**PLANNING COMMISSION
SPECIAL AGENDA
MONDAY, JULY 22, 2024 @ 6:30 PM
CITY HALL, 6408 ELM STREET, NORTH
BRANCH, MN 55056**

Subject: Public Hearing for Comprehensive Plan Amendment, Rezoning, and Text Amendment for LIUNA Vocational Training Facility

Re: Sunrise Bluff 3rd Addition Plan Review
WSB Project No. 025975-000

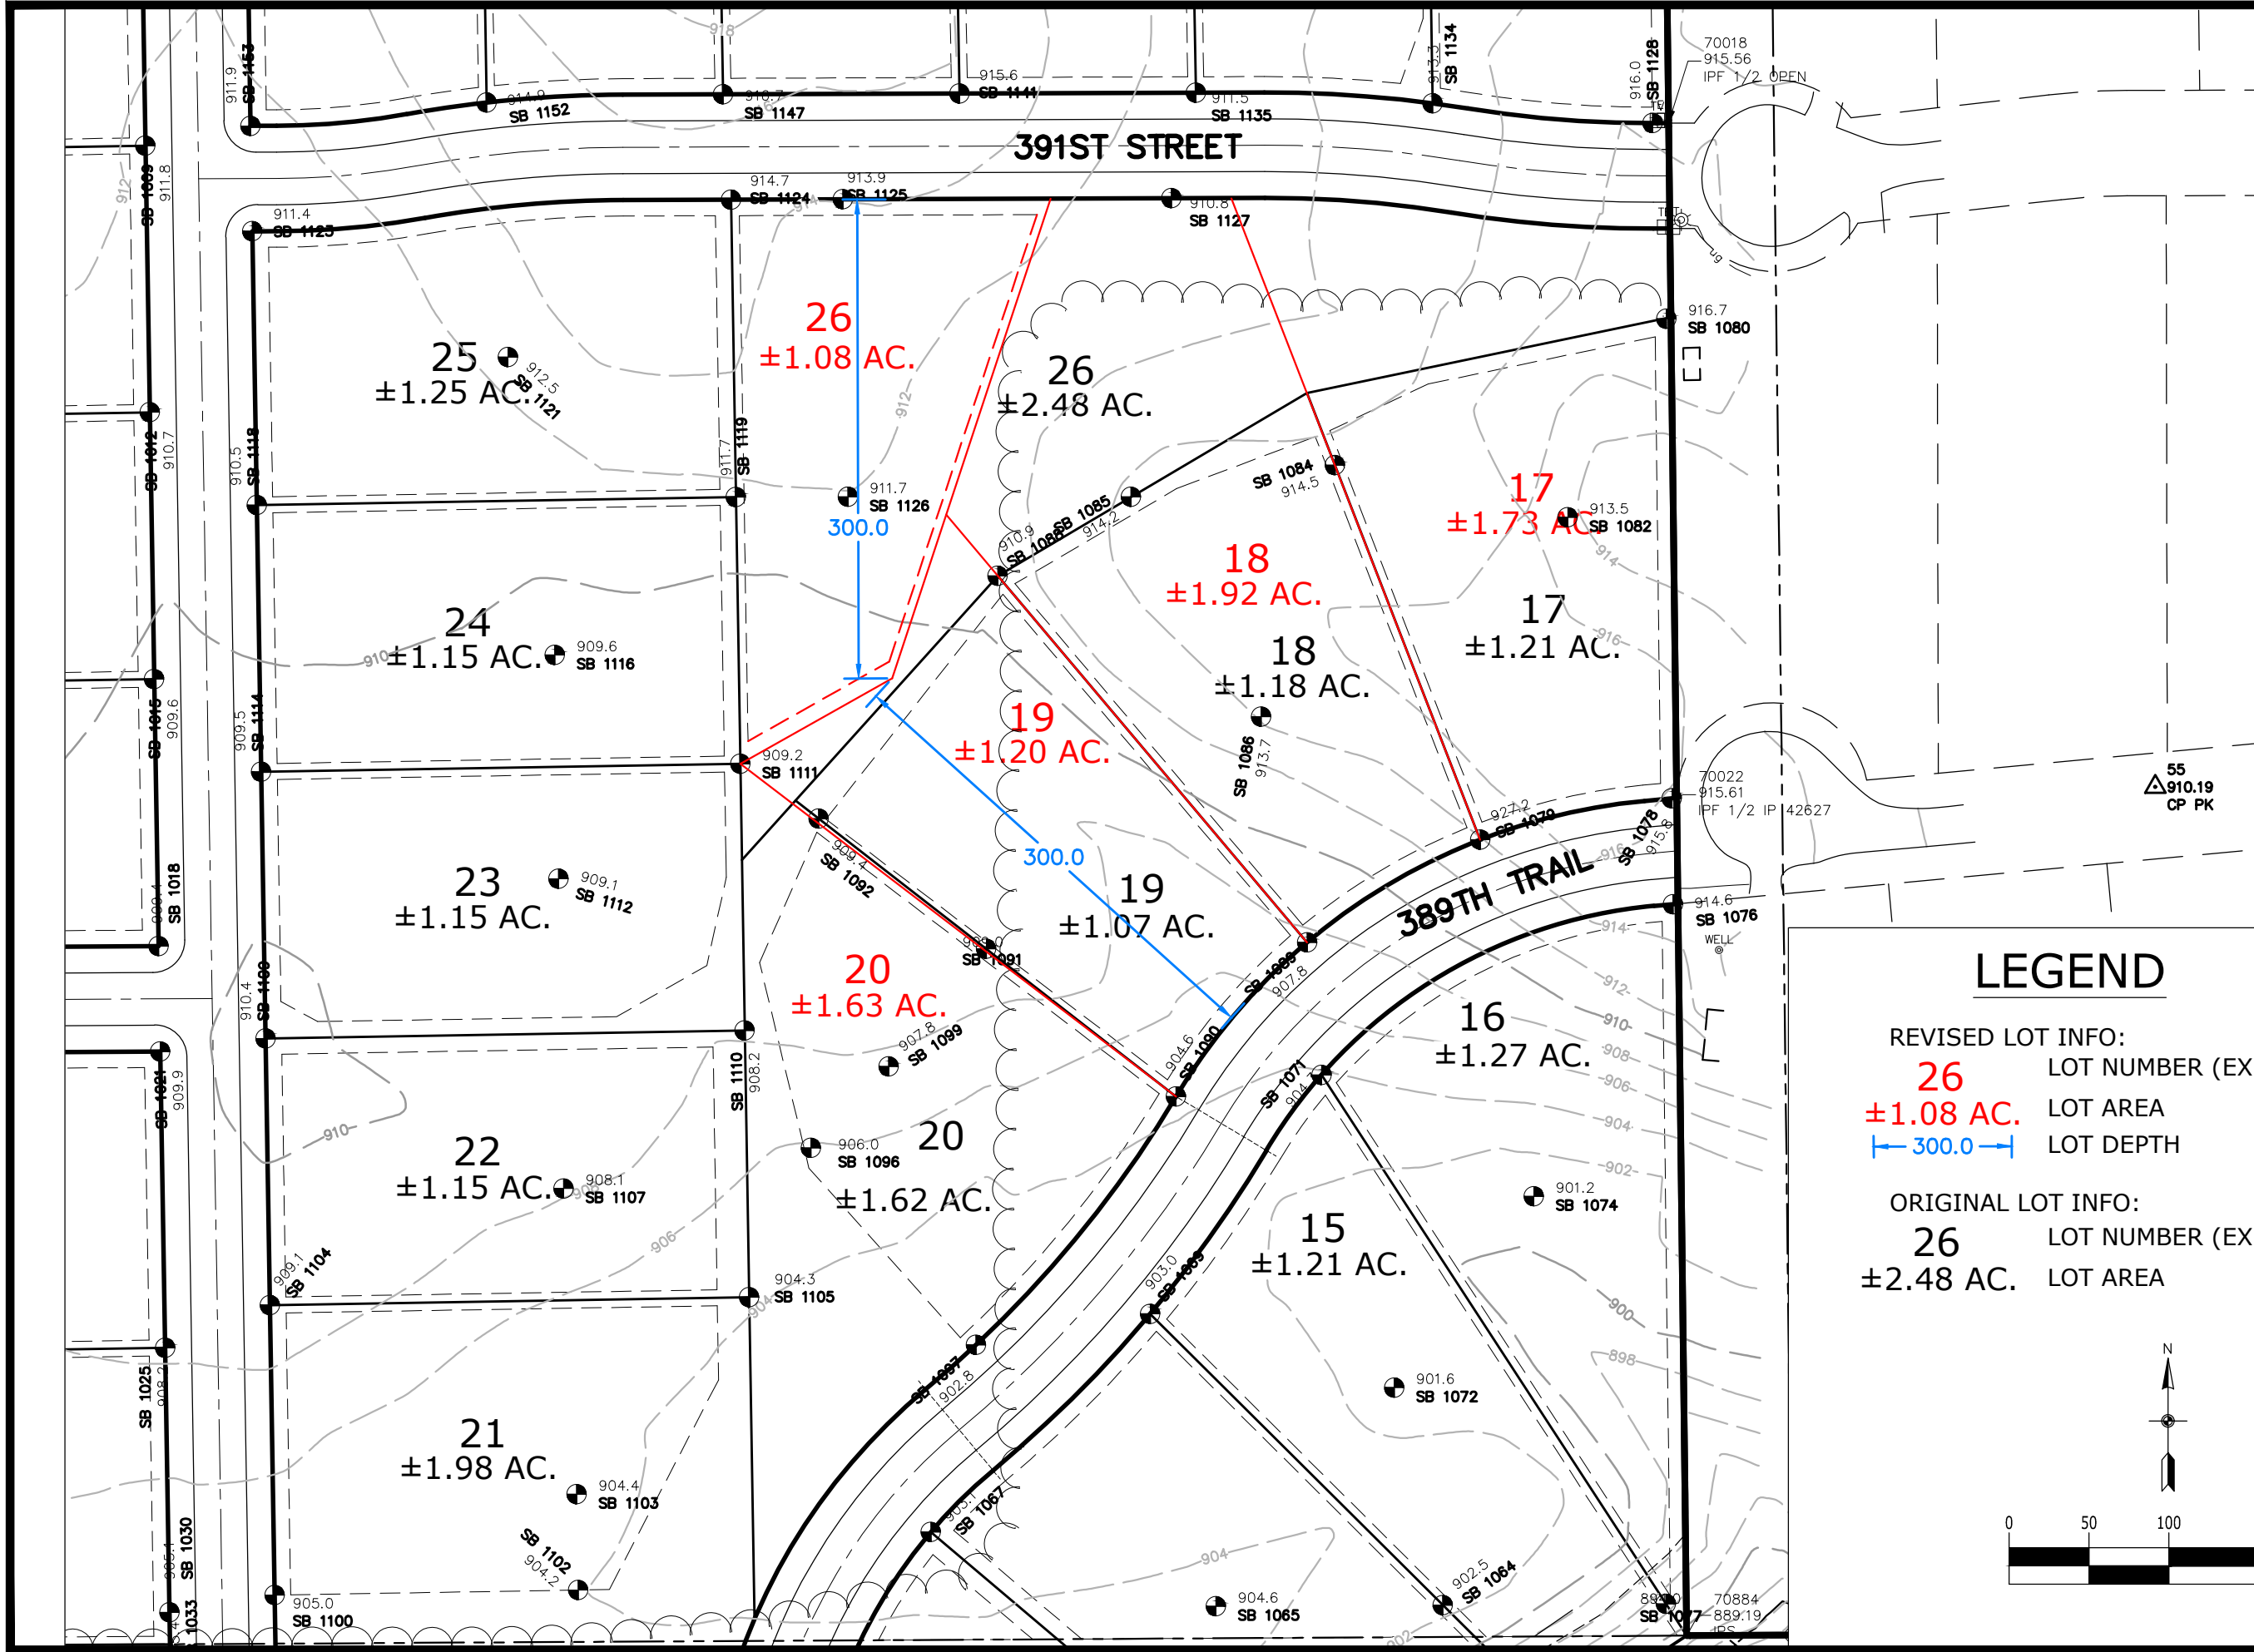
12. Driveways are not currently shown on the plans. Confirm if driveway culverts are needed and provide sizing information for any culverts proposed.
13. Confirm construction entrance location(s) shown on plans.

19. The top and bottom elevation of the proposed retaining wall on Lot 114 should be noted on the plans.
20. Note the proposed contour labels under the buildings to ensure the contours match the ground elevations.

21. Clarify the existing and proposed contours on the plan (dashed-screened; solid-screened; solid-bold)
22. Confirm the existing electric easement can be used for City maintenance access to the proposed storm sewer outlet.

23. Note the proposed invert elevations for the proposed culvert on Lot 112.
24. Riprap should be shown on the grading and erosion control plans.
25. Install perimeter control around the wetland limits.

26. It should be confirmed if the FEMA floodplain linework is shown on the grading plans currently. If not, this should be added.

REVISED LOT INFO:

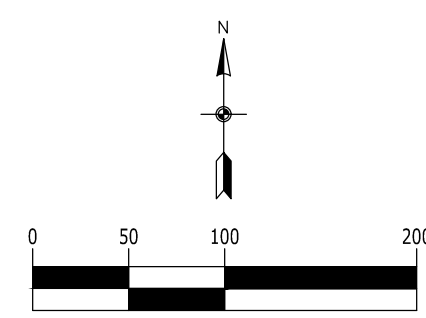
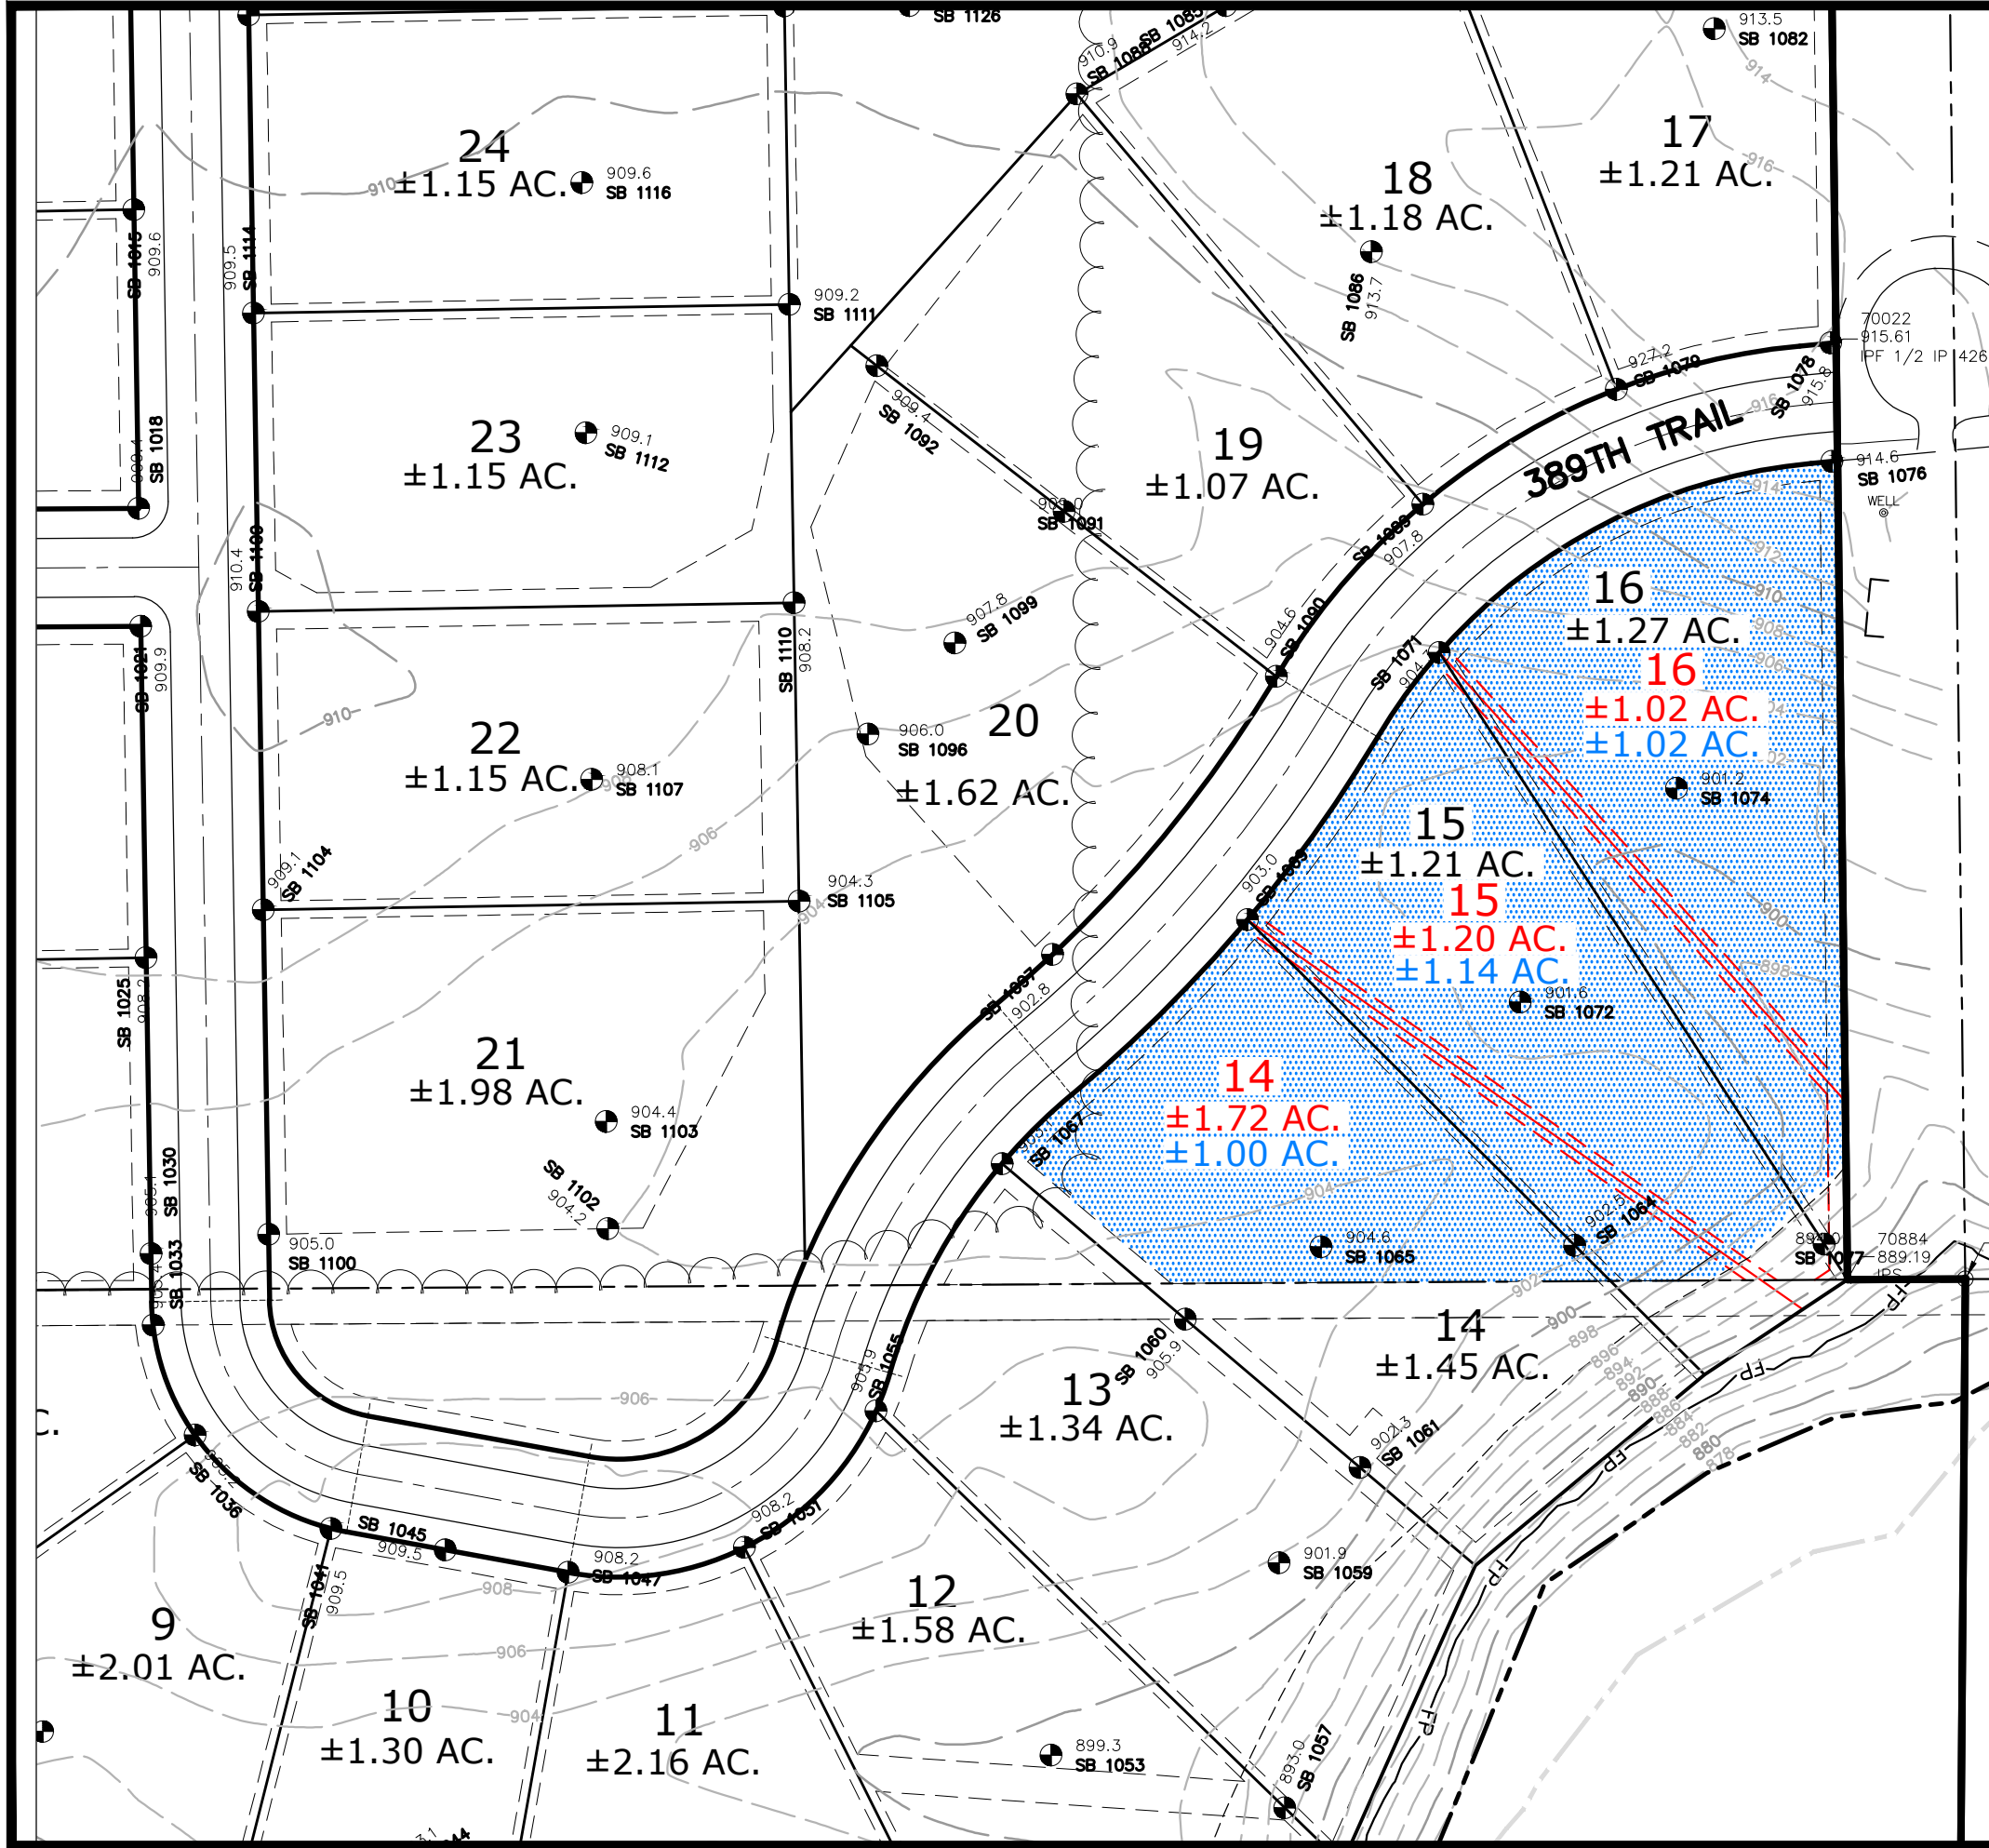
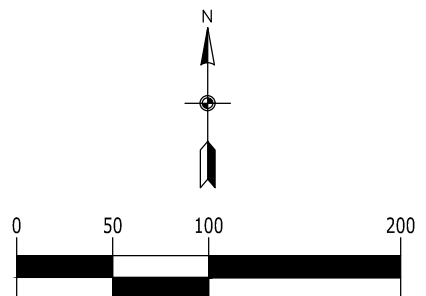
Secondly, Lots 1, 2, 3, and 10 of Block 3 do not meet the lot depth requirements as measured from the center of the lot. Lot depth is defined in the City Code as "shortest horizontal distance between the front lot line and the rear lot line measured from a 90-degree angle from the street right-of-way within the lot boundaries." When measuring at the center of Lots 1-3, the lot depth is approximately 290', not the required 300'. Additionally, Lot 10 has a depth of 56' at the eastern property line. The Developer put together a redlined plat document for the Commission to review to show how the lots would look, if they met the 300' minimum depth. Staff believes this would be a better design, and has advice the developer to continue to draft plat documents that reflect this change.

- Lots 1, 2, 3, and 10 of Block 3 do not meet the lot depth requirements as measured from the shortest point to the street right-of-way. Provide updated plans that meet the 300' depth requirement.
